Office Action Summary

10/607,906

KOST ET AL.

DETAILED ACTION

Included below is a modified figure identifying the claimed structure.

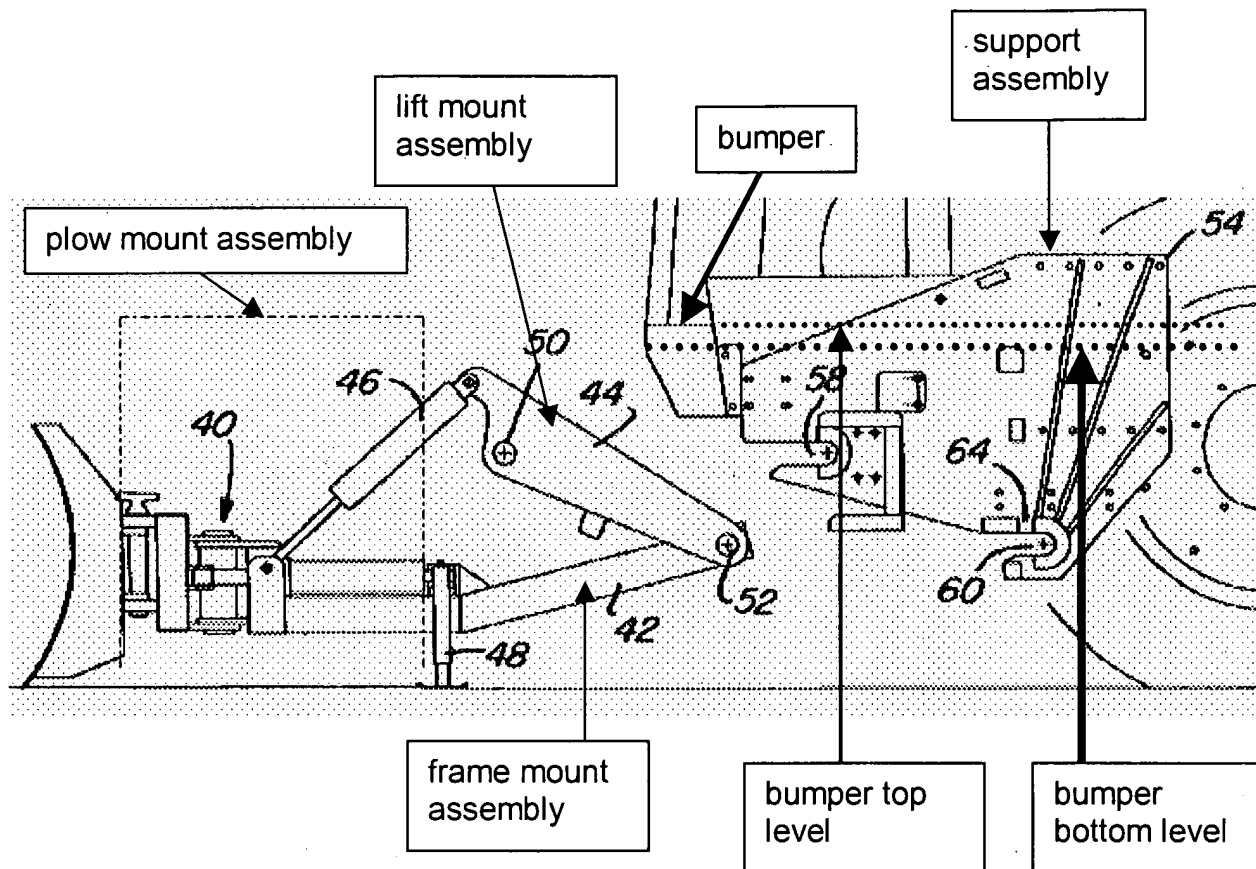
Malinowski discloses a snowplow blade mount having all of applicant's claimed structure including a frame mount assembly (including 42), a lift mount assembly (including 44), a support assembly (including members 54) having a connection end (including 58), and a plow mount assembly (considered the structure that connects the plow blade to the frame mount assembly and lift mount assembly), with the plow mount assembly detachably connected to the support assembly and including a leg support 48 as shown in figure 7. It is noted that latch bars 50 & 52 are considered removable pins since they are removable from sockets 58 & 60. It is noted that the entrance structure of sockets 58 & 60 are considered guide sections and landings, with the outermost edge being considered the guide section (see figure 7). It is noted that since the lift mount assembly is connected to cylinder 46 and the frame mount assembly by a pinned

connection, it is considered to be detachably connected. Additionally, member 48 is considered a skid plate.

assembly, only that the plow mount assembly is "connectable" to the support assembly. Secondly, two things can be connected to each other by way of their common connection to something else. *Kreis AG v. American Hospital Supply Corp.* (DC NIII) 192 USPQ 585. Clearly, since the plow mount assembly is connected to the frame mount assembly, which is in turn pivotally connected to the support assembly, the plow mount assembly is pivotally connected to the support mount assembly. Additionally, it is noted that the modified figure above shows the identified plow mount assembly being spaced from the frame mount assembly.
